SERVICE LETTER

No. 707

Modified Flyball Assembly to Improve RPM Control
-- reference attached Hartzell Service Letter No. 75,
dated November 16, 1973.

SERVICE LETTER NO. 75

A-153(A)-(C) FLYWEIGHT (SEE CHART)
(MATERIAL GROUND FROM
SIDES ON "A" MODIFICATION)

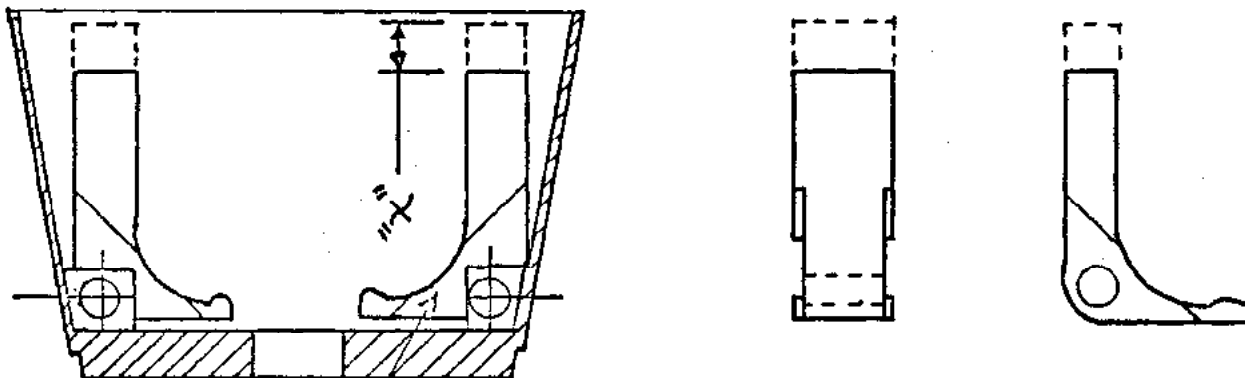
Discussion: To effect an improved RPM control on aircraft with the Hartzell governors, a modified flyweight assembly designed to absorb the torsional motions of the drive gear are being installed in all Hartzell production governors.

- 1) Determine flyweight assembly needed using parts listed in this letter.
- 2) The flyweight assembly can be changed by:
 - a) removing cover assembly
 - b) removing flyweight assembly locking ring
 - c) removing flyweight assembly
 - d) placing new flyweight assembly in place
 - e) replacing lock ring, making sure it is in place
 - f) replacing cover gasket 50672, and
 - g) installing cover assembly
